SERVICE BULLETIN

N° 139-658

ATA 23 - SATCOM FLIGHTCELL DZMX (4G) UPGRADE RETROMOD

This Service Bulletin is issued in order to provide the necessary instruction on how to perform the installation of SATCOM Flightcell DZMX (4G) upgrade retromod P/N 3G4390P00811.

Figure 1

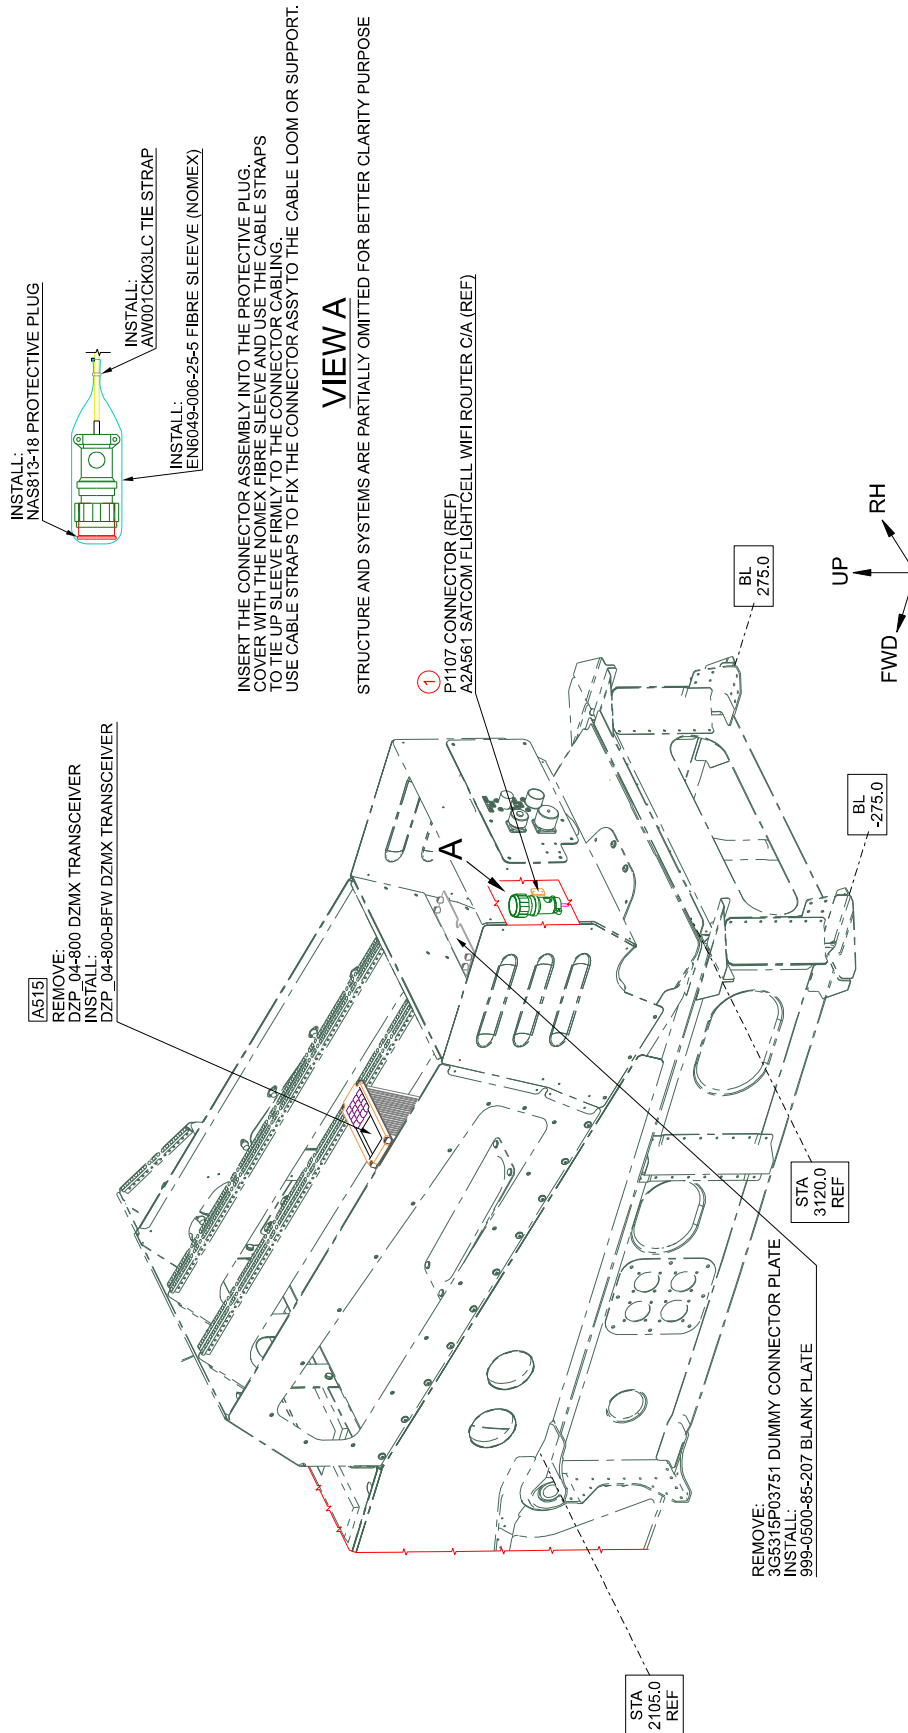
- 2.1 In accordance with AMP DM 39-C-23-97-01-00A-520A-K and with reference to Figure 1 Isometric View and Figure 2 View Looking Interseat Console LH Side, remove the DZMX transceiver P/N DZP_04-800.

- 2.2 With reference to Figure 1 Isometric View and Figure 2 View Looking Interseat Console LH Side, install the DZMX transceiver P/N DZP_04-800-BFW and connect the connectors A515P1, A515P2, A515P3, A515P4 and A515P5.

- 2.3 With reference to Figure 1 Isometric View and Figure 2 View Looking Interseat Console LH Side, disconnect the connector P1107 and install the support P/N AW001CL001-N6 by means of Adhesive Hysol EA9309 NA (C231) or EA9309.3NA.

- 2.5 With reference to Figure 1 Isometric View and Figure 2 View Looking Interseat Console LH Side, remove the dummy connector plate P/N 3G5315P03751 and install the blank plate P/N 999-0500-85-207 with previously removed hardware.

- 2.10 With reference to Figure 1 Isometric View and Figure 3 View Looking Forward Rear, install the lock ring P/N AW001YC01RED on the SATCOM WIFI circuit breaker of the remote circuit breaker panel.

Figure 2

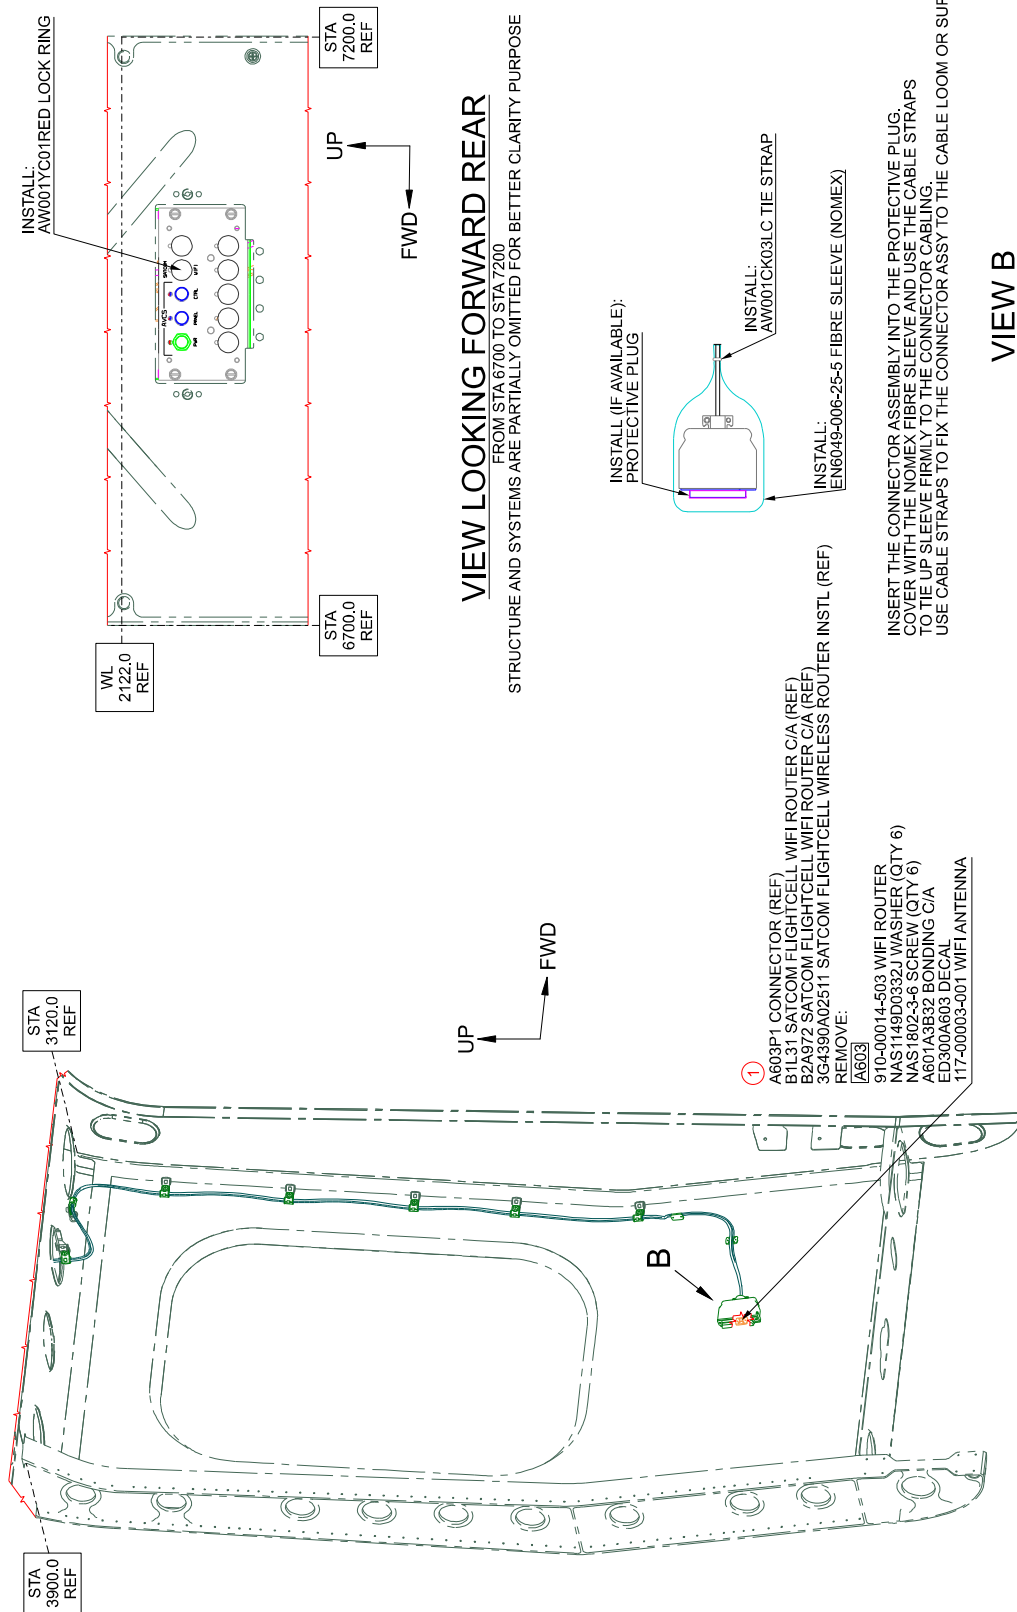
- 2.4 With reference to Figure 2 View A, protect the connector P1107 with protective plug P/N NAS813-18, fibre sleeve (Nomex) P/N EN6049-006-25-5 and tie strap P/N AW001CK03LC.

INSERT THE CONNECTOR ASSEMBLY INTO THE PROTECTIVE PLUG. COVER WITH THE NOMEX FIBRE SLEEVE AND USE THE CABLE STRAPS TO TIE UP SLEEVE FIRMLY TO THE CONNECTOR CABLING. USE CABLE STRAPS TO FIX THE CONNECTOR ASSY TO THE CABLE LOOM OR SUPPORT.

INSTALL ELECTRICAL SUPPORT REPORTED IN TABLE BELOW:

LOCATION NUMBER	PART. NUMBER	STA	BL	WL	ORIENTATION
①	AW001CL001-N6	3164	-199.5	1306	90°
